SUBJECT: 610 RUTHERFORD AVENUE, CHARLESTOWN

SUMMARY: This Memorandum requests that the Boston Redevelopment Authority ("BRA") d/b/a the Boston Planning & Development Agency authorize the Director to: (1) issue a Certification of Approval for the proposed development located at 610 Rutherford Avenue in Charlestown (the "Proposed Project"), in accordance with Article 80E, Small Project Review, of the Boston Zoning Code (the "Code"); (2) enter into an Affordable Housing Agreement in connection with the Proposed Project, and take any other actions and execute any other agreements and documents that the Director deems appropriate and necessary in connection with the Proposed Project; (3) execute a Community Benefits Agreement, and take any other action and execute any other agreements and documents that the Director deems appropriate and necessary in connection with the Proposed Project, and (4) recommend approval to the City of Boston Zoning Board of Appeal on Petition BOA - 829615 for zoning relief necessary to construct the Proposed Project with the proviso that the plans be submitted to the BPDA.

Re: 32 Cambridge Street - Abutter Code Review
TC Project # 18.6059

Figure 1: Site Condition

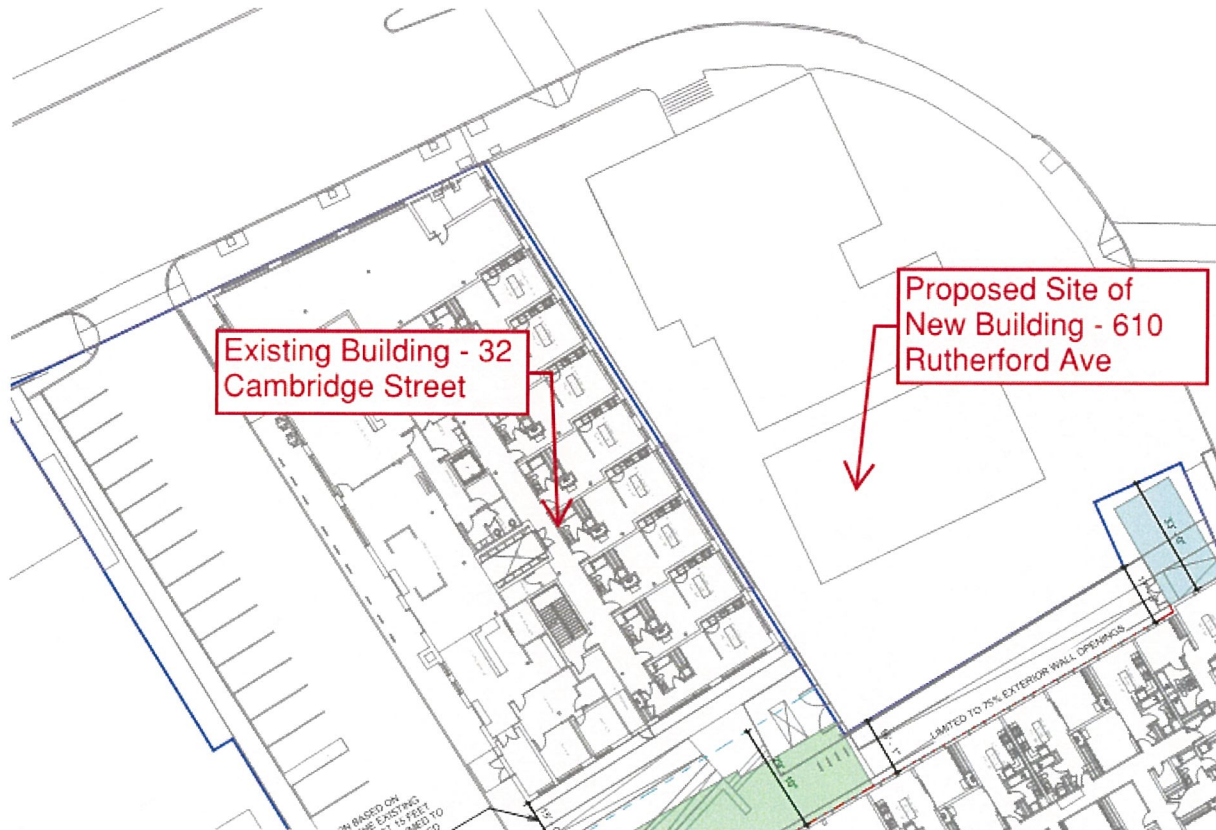
Openings in an exterior wall are limited based on FSD to limit the possibility of a structure fire spreading to adjacent buildings per 780 CMR Table 705.8; however, existing buildings are granted leniency. As an existing building undergoing a change of occupancy classification that does not result in a higher exterior wall fire-resistance rating hazard category, the openings and exterior wall ratings which existed prior to the change of use were permitted to remain per 780 CMR 34.00 Section 912.6.2.

The building has approximately 32% openings where it abuts the proposed new structure at 610 Rutherford Avenue. A minimum FSD of ten feet is required when 32% openings are provided to comply as-of-right with the code for new construction (i.e. 780 CMR Table 705.8). Approximately 18' of separation is currently provided between the existing building at 32 Cambridge Street to the existing building at 610 Rutherford Avenue. The proposed building is configured such that the separation distance will be decreased to approximately eight feet. The figure below shows the condition. The proposed building exacerbates the existing condition of openings in excess of those permitted by the code for new construction by decreasing the separation from adjacent buildings.

Based on the above analysis, it is our opinion that the proposed building (1) creates a more hazardous condition than currently exists, and (2) does not comply with the building code with respect to openings in the exterior wall.
